**BELL SYSTEM PRACTICES**  
**Private Branch Exchange**  
**Installation and Maintenance**

**SECTION B522.251**  
**Issue 2, 1-3-38**  
**AT&T Co Standard**

# **MODIFICATION FOR ANTI-SIDETONE CONNECTIONS**

## **505 AND 506 TYPE P.B.X.'s**

**Fig. 1—Wiring of Telephone Circuit for Anti-Sidetone Connections 505 Type P.B.X.'s. (For Boards Where (BK) Cord Fastener Has to Be Added.)**

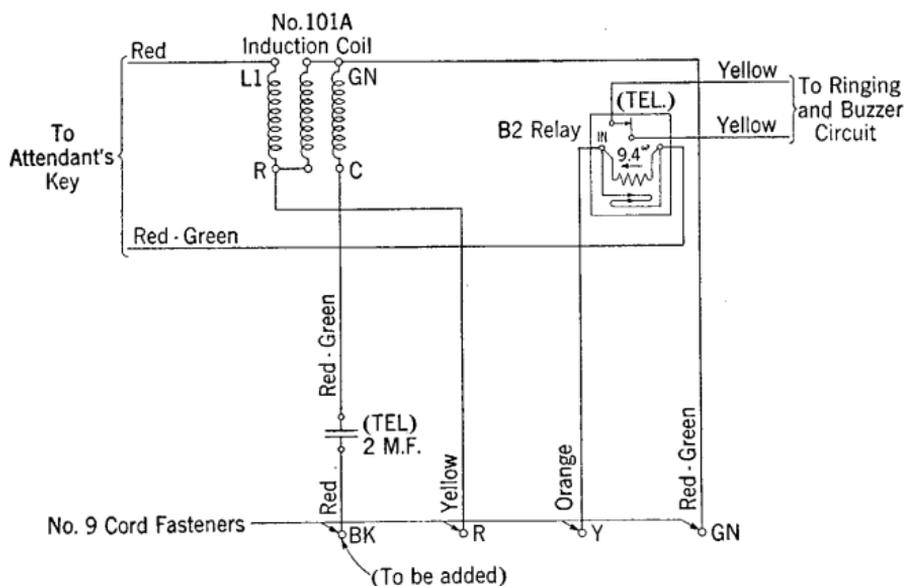
3.02 Disconnect all wiring from the No. 46 induction coil. This wiring should be unsoldered carefully so that it will not be broken or have the insulation burned or badly frayed as it is to be reconnected to the No. 101A induction coil.

3.03 Disconnect the red-green wire which runs between the (IN) winding of the B2 (TEL) relay and the 2 M.F. (TEL) condenser. Also disconnect the yellow-green wire which runs between the 21-E (TEL) condenser and the (Y) cord fastener.

3.05 Remove the No. 46 induction coil and replace it with the No. 101A induction coil. The No. 101A coil is most readily mounted by first installing one of the mounting screws so that the slotted mounting lug of the coil will slide snugly under the screw head. Then install the other mounting screw.

3.06 Locate the new No. 9 cord fastener in line with the existing cord fasteners and designate it (BK) except on boards equipped with a cord fastener designated (C) in

which case redesignate it (BK) instead of adding a new cord fastener.

3.07 Run a single No. 22 D.S.C.C. orange wire between the (IN) winding of the B2 (TEL) relay and the (Y) cord fastener.

3.08 On boards where the (BK) cord fastener has been added run a single No. 22 D.S.C.C. red wire between the 2 M.F. (TEL) condenser and the (BK) cord fastener.

3.11 Connect the wiring to the induction coil, relay, condenser and cord fasteners in accordance with Fig. 1 or 2.

**Fig. 2—Wiring of Telephone Circuit for Anti-Sidetone Connections 505 Type P.B.X.'s. (For Boards Where (BK) Cord Fastener Was Formerly Designated (C).)**

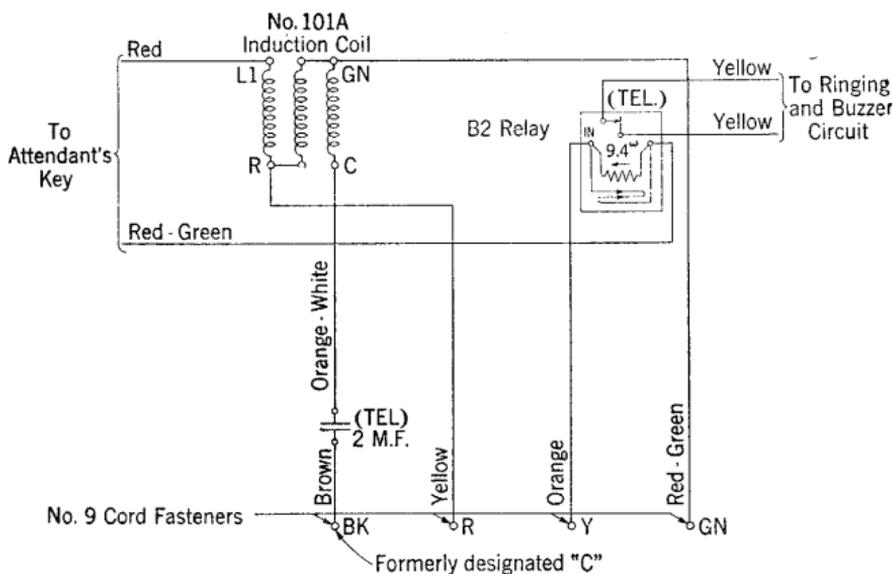
3.04 When a board is equipped with four cord fasteners, one of which is designated (C), disconnect in addition to the wires mentioned in paragraph 3.03, the red wire which runs between this (C) cord fastener and the No. 3 terminal of the induction coil.

3.09 On boards where the (C) cord fastener has been redesignated (BK) and no new cord fastener has been added, run a single No. 22 D.S.C.C. orange-white wire between the (TEL) condenser and the (C) terminal of the induction coil.

**Fig. 3—Wiring of Telephone Circuit for Anti-Sidetone Connections 506 Type P.B.X.'s**

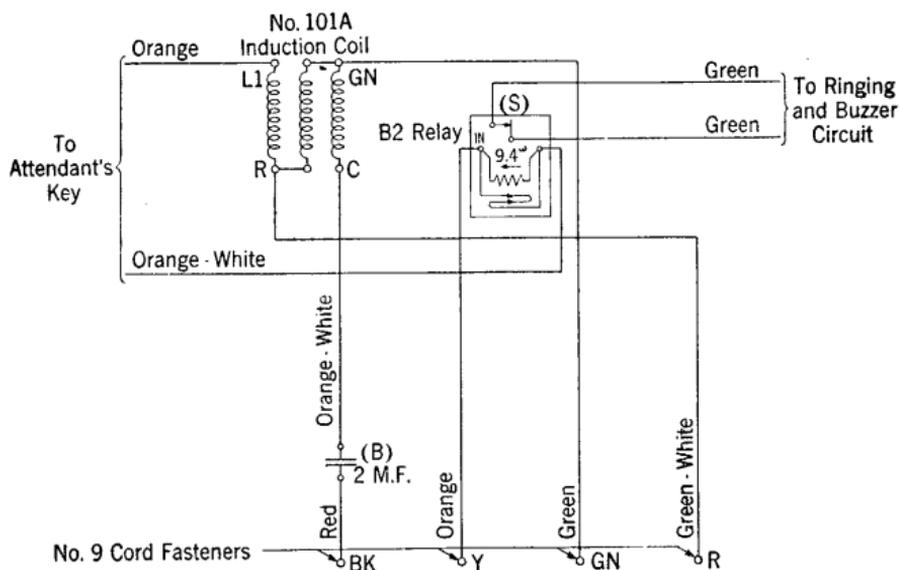
3.17 Disconnect the orange-white wire which runs between the (IN) winding of the B2 (S) relay and the 2 M.F. (B) condenser.

3.18 If the red wire which runs between the 2 M.F. (B) condenser and the (Y) cord fastener is not long enough to reach the location of the new (BK) cord fastener as covered by 3.21, disconnect this wire at both the (Y) cord fastener and the 2 M.F. (B) condenser.

3.19 If the red wire which runs between the 2 M.F. (B) condenser and the (Y) cord fastener is long enough to reach the location of the new (BK) cord fastener as covered in 3.21, disconnect this wire only at the (Y) cord fastener.

3.20 Remove the No. 46 induction coil and replace it with the No. 101A induction coil as covered in 3.05.

Note: In the No. 506B P.B.X.'s install one mounting detail P-236668 on the drillings for the No. 46 induction coil and mount the No. 101A induction coil on this detail.

3.21 Locate the new No. 9 cord fastener in line with the existing cord fasteners and designate it (BK).

3.22 Run a single No. 22 D.S.C.C. orange wire between the (IN) winding of the B2 (S) relay and the (Y) cord fastener.

3.23 Run a single No. 22 D.S.C.C. red wire between the 2 M.F. (B) condenser and the (BK) cord fastener if the wire mentioned in the note following 3.18 has been cut off at the cable form. These new leads may be superimposed on the existing local cable form.

3.24 Connect the wiring to the induction coil, relay, condenser and cord fasteners in accordance with Fig. 3.
